**CONFIRMATORY SURVEY ACTIVITIES  
FOR THE  
FORT ST. VRAIN NUCLEAR STATION  
PUBLIC SERVICE COMPANY OF COLORADO  
PLATTEVILLE, COLORADO**

Fort St. Vrain Nuclear Station - March 21, 1996

At the request of the NRC's Division of Waste Management, the Environmental Survey and Site Assessment Program (ESSAP) of the Oak Ridge Institute for Science and Education (ORISE) performed independent confirmatory surveys activities at the Fort St. Vrain site in Platteville, Colorado. During the period January 22 through 25, 1996, ESSAP performed instrument comparison activities—including side-by-side surface activity measurements and surface scans—and reviews of the licensee's embedded piping program and planned use of *in situ* gamma spectrometry for determining the licensed material contribution to exposure rate.

FIGURE 1: Turbine Building Level 7, Deck Southwest General Area, Survey Unit C031

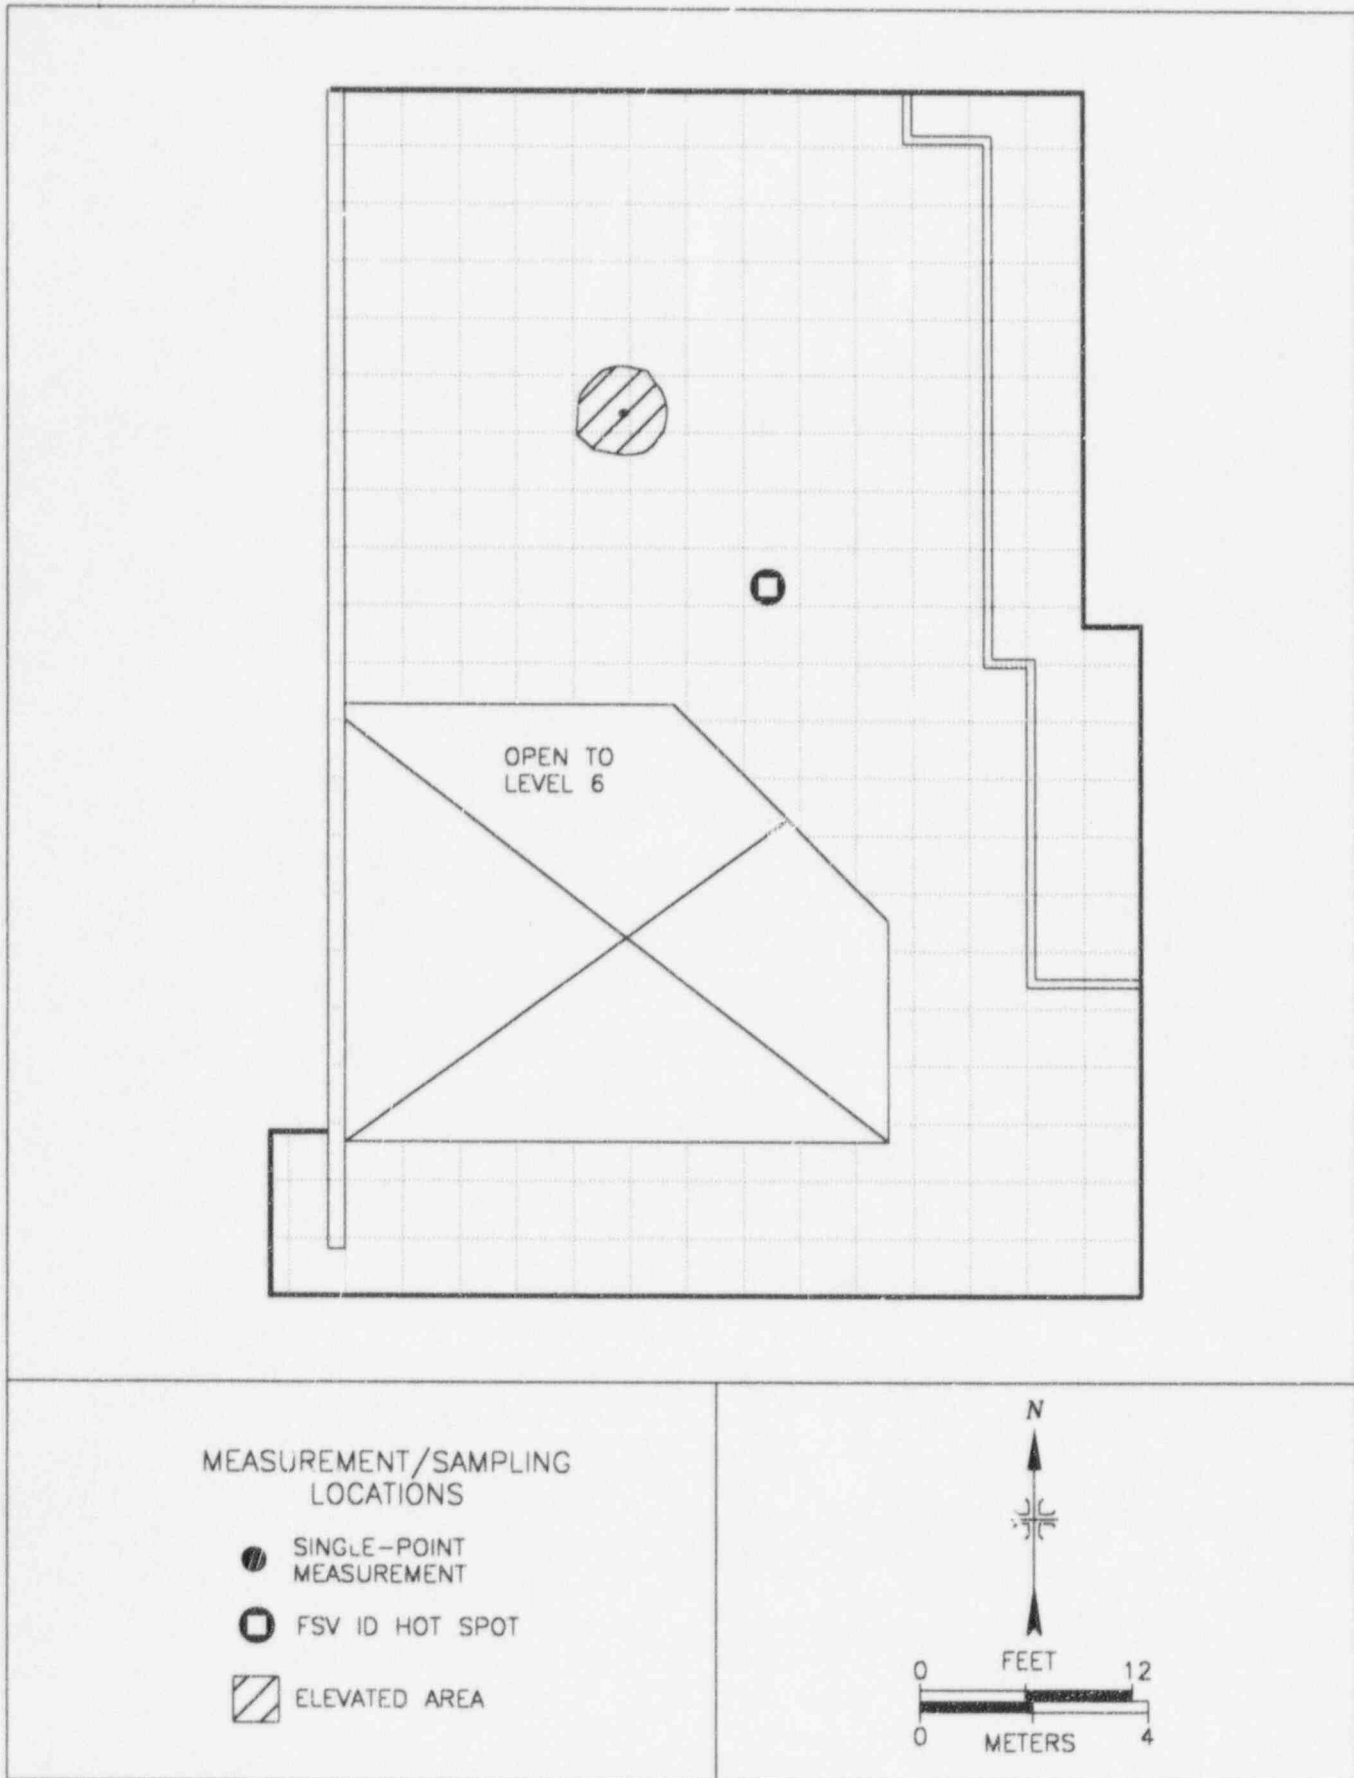
C031 is an affected area located on the Level 7 of the Turbine Building with a floor area of approximately 254 m<sup>2</sup>. The floor surface was covered with a red tile that is not located in any other area of the plant, which eliminated the possibility of establishing a material-specific background (the licensee used outdoor concrete as an equivalent surface for a red tile background). The wall surfaces were comprised of steel and concrete. One hundred percent of both floor and lower wall surfaces were scanned, with the exception of the wall area over the portion of the floor that was open to Level 6. An elevated area (3000 to 4000 cpm) extending over a few square meters was identified, while the remainder of the floor area had a scan range of 2000 to 2700 cpm—consistent with background levels. No elevated direct radiation was detected on any of the wall surfaces. A direct measurement within the elevated floor area resulted in an activity of 2000 dpm/100 cm<sup>2</sup>.

FIGURE 2: Building 10, Survey Unit C046

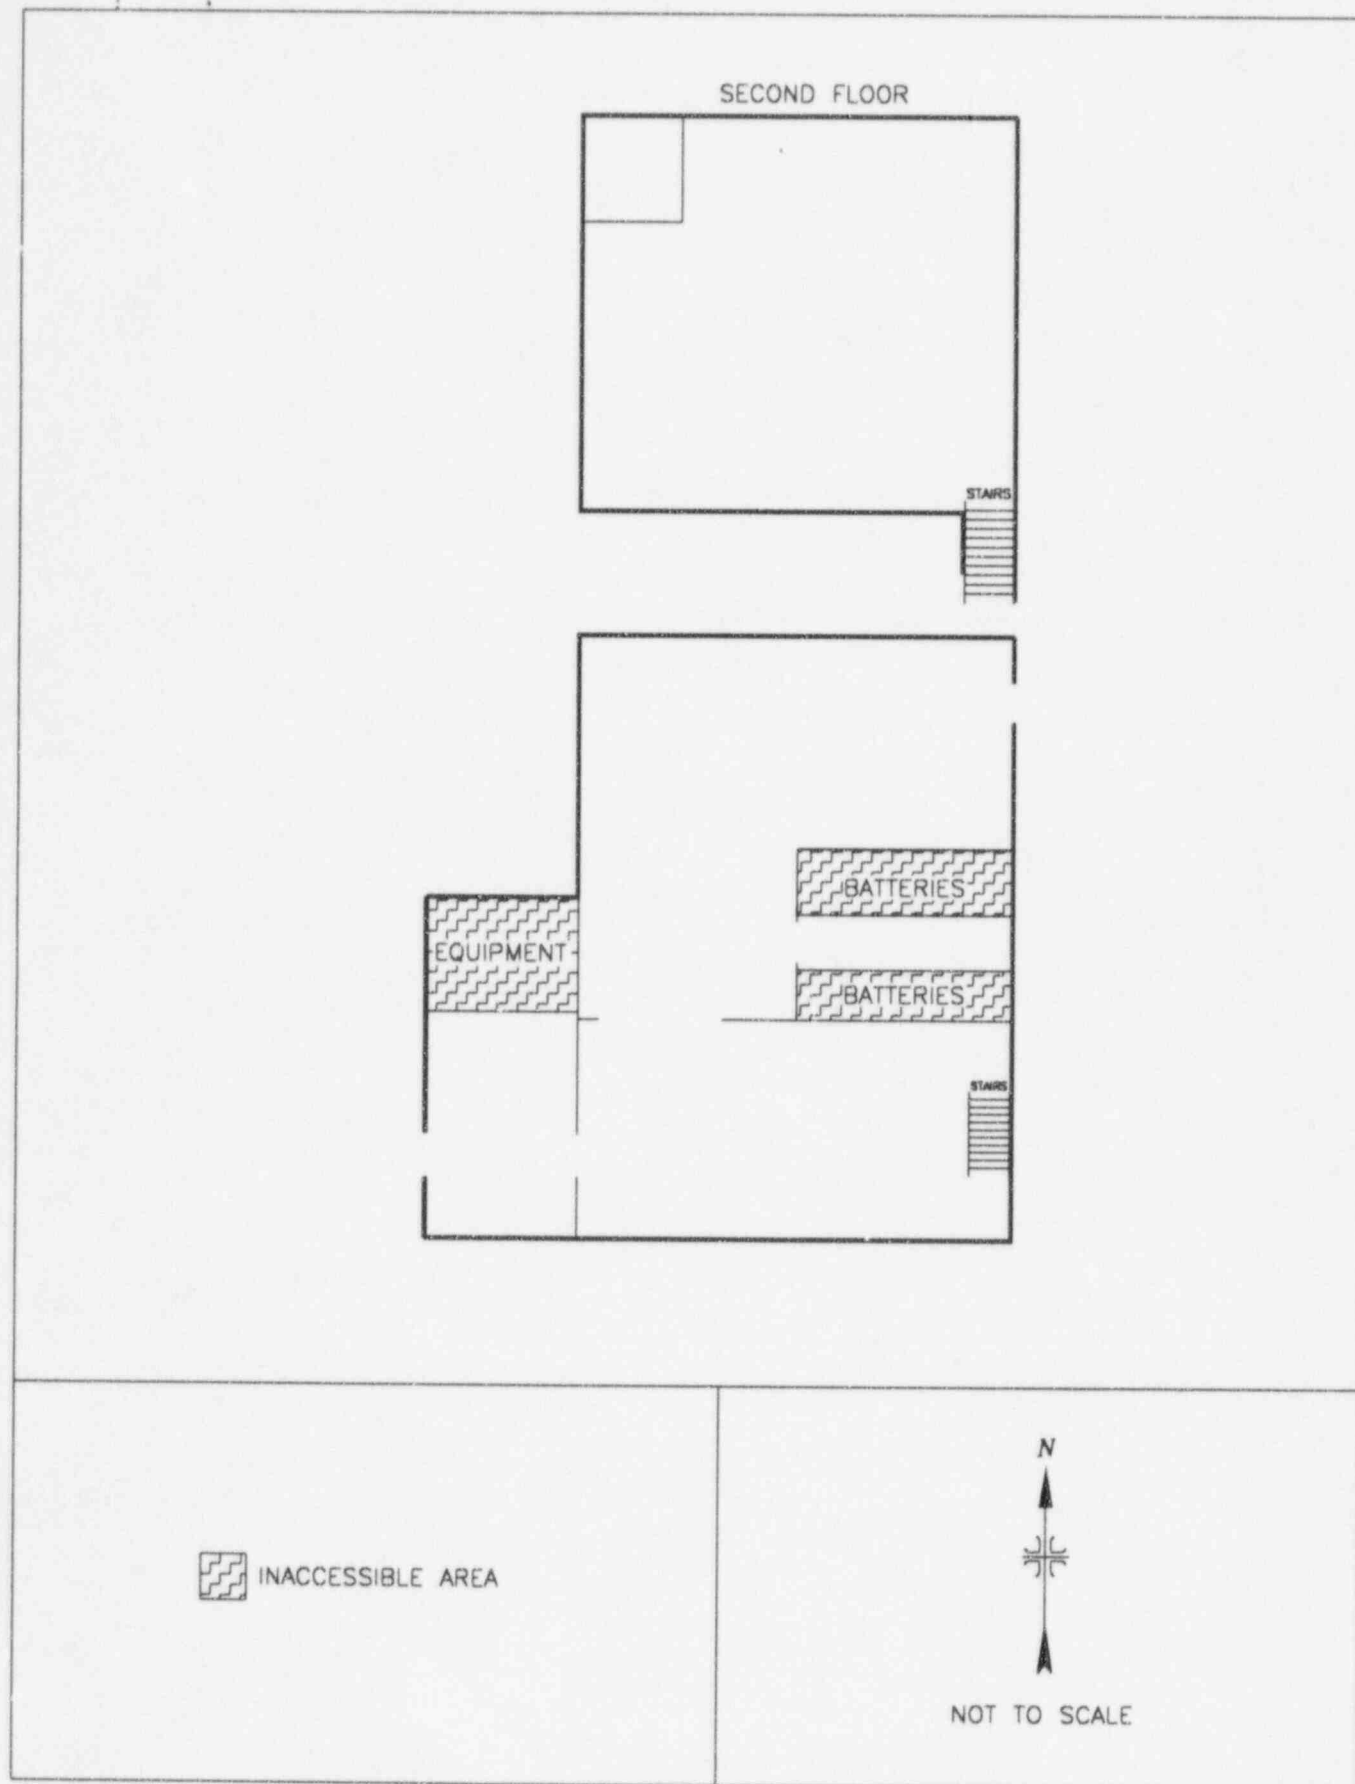
C046, located within Building 10, is an unaffected area with an approximate floor space of 184 m<sup>2</sup>. This survey unit includes four lower level rooms and a second level loft area. No areas of elevated direct radiation were detected on the floors or lower walls. Scan ranges were consistent with background levels—1700 to 2600 cpm and 400 to 800 cpm for the floors and lower walls, respectively.

FIGURE Turbine Building, Level 5, South General Area, Survey Unit C005

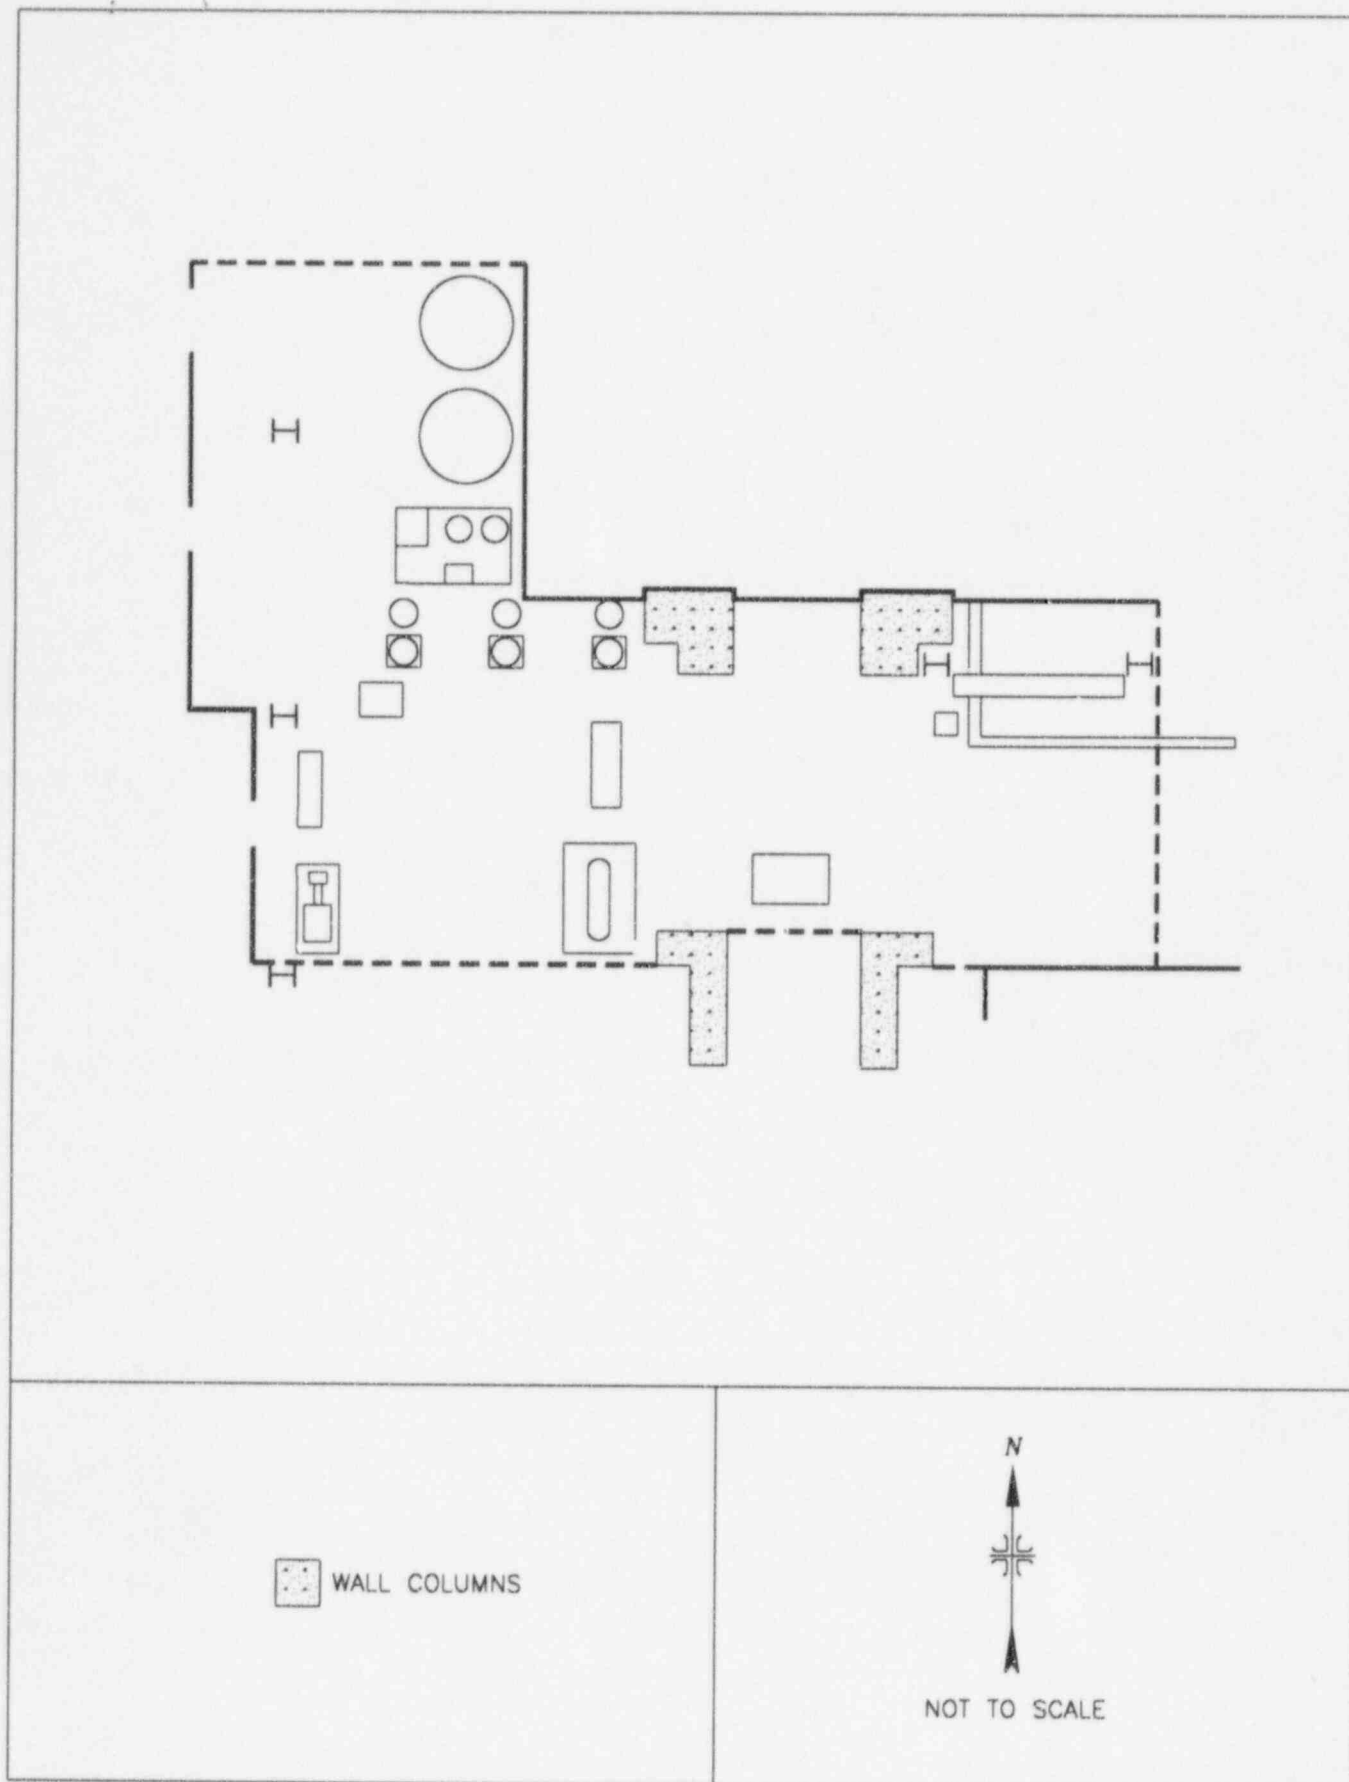
Located on Level 5 of the Turbine Building is the unaffected 322 m<sup>2</sup> survey unit, C005. The floors and walls are constructed with concrete and the area is congested due to plant systems and stored equipment. Therefore, scans were limited to approximately 40 to 50% of the floor area. Due to the small amount of wall space, some equipment was scanned. No locations of elevated direct radiation were detected throughout the survey unit and the scan ranges were 1300 to 2000 cpm and 300 to 500 cpm for the floor and walls, respectively.

FIGURE 4: Reactor Building, Level 3, East, Northeast General Area, Survey Unit F044

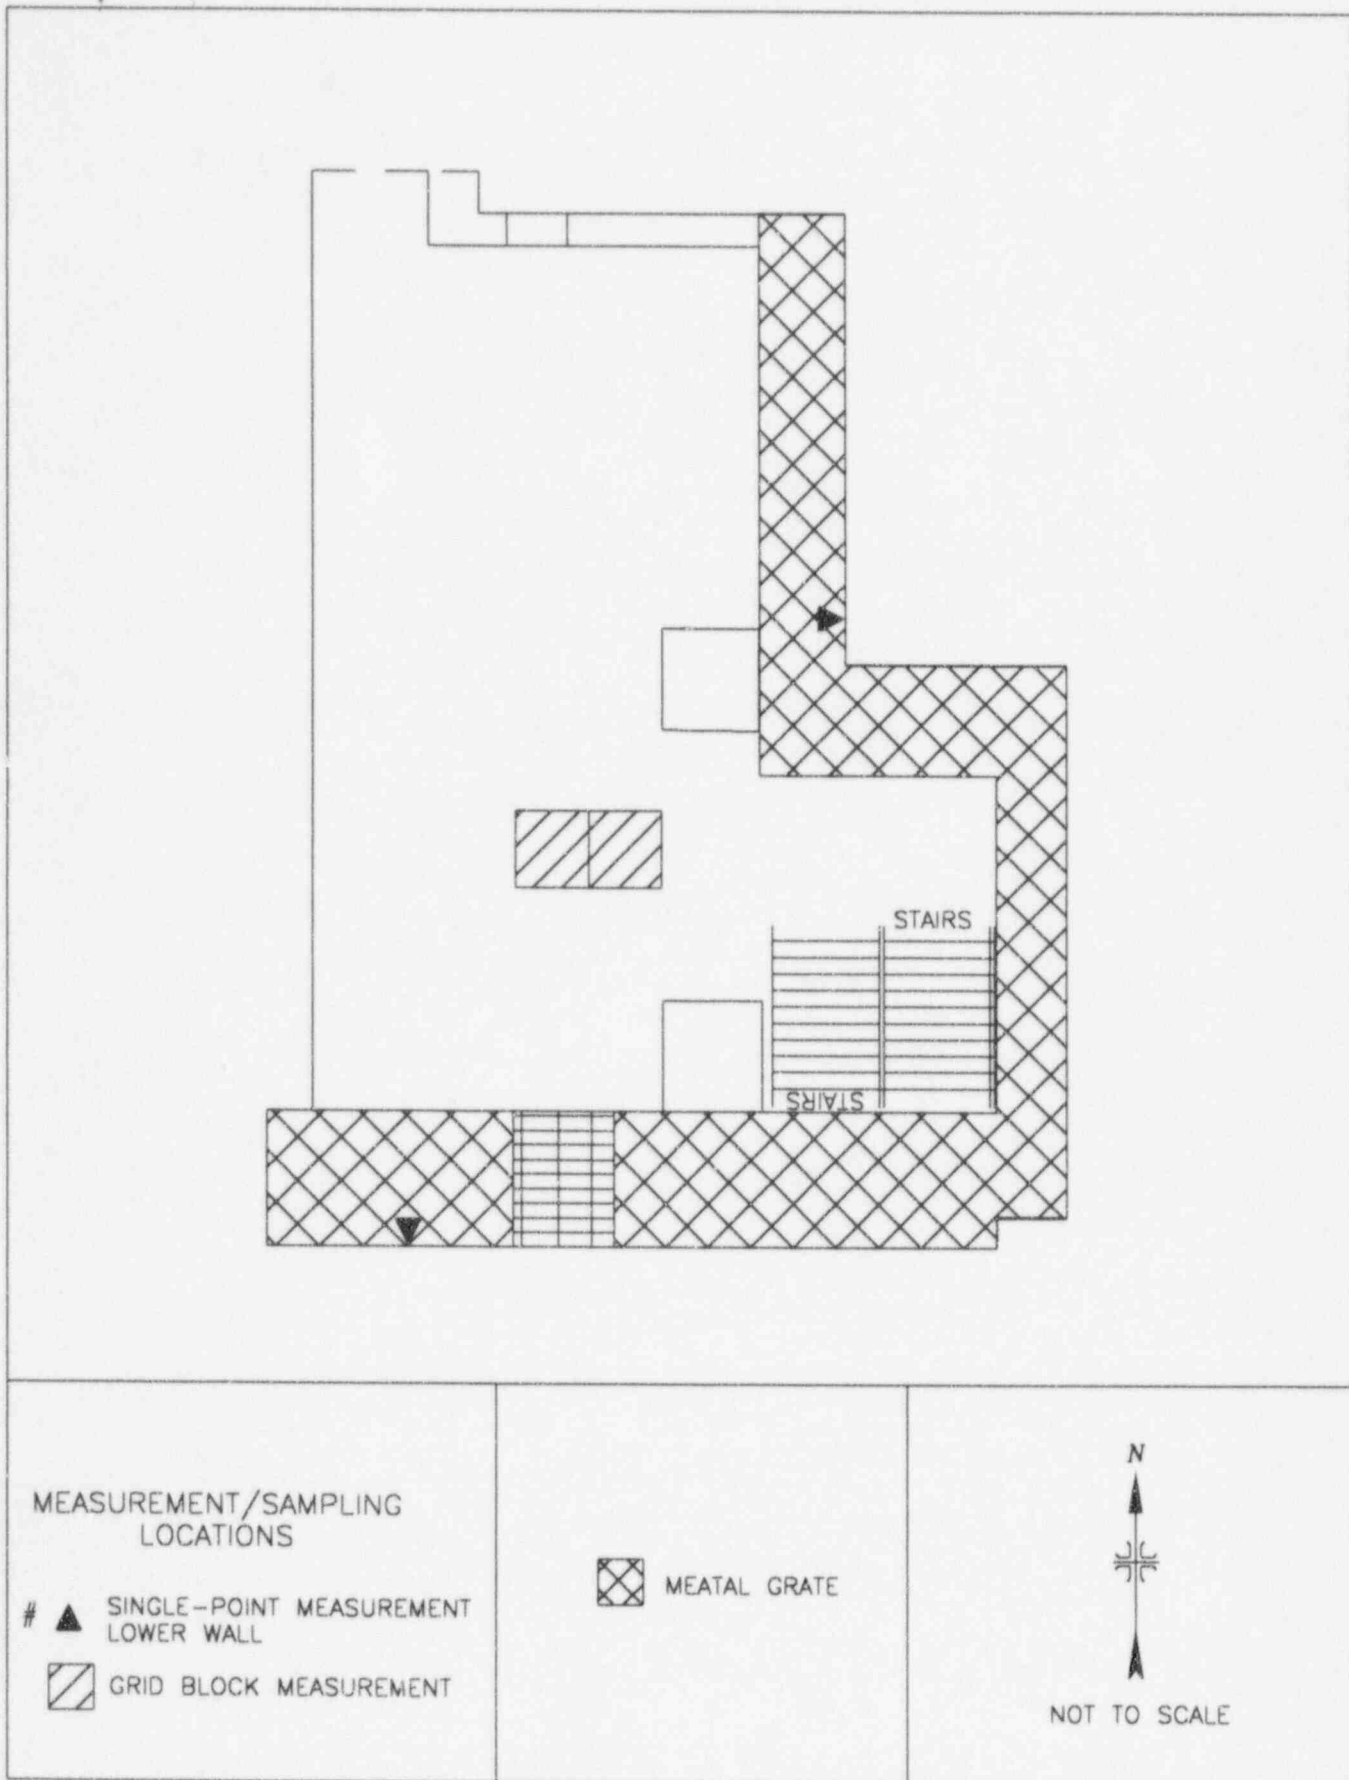
F044 is an affected area located on Level 3 of the Reactor Building with 177 m<sup>2</sup> of floor space. Floors were of concrete and steel grate construction, while walls consisted of concrete blocks. Three locations, each less than one square meter in size, ranging from 3100 to 5100 cpm were identified on the floor. Surface activity measurements on two of the floor areas were 6300 to 8700 dpm/100 cm<sup>2</sup>. Subsequent to the ESSAP scan of this survey unit it was recognized that the licensee had not completed this survey package and that comparisons to licensee data were not appropriate.
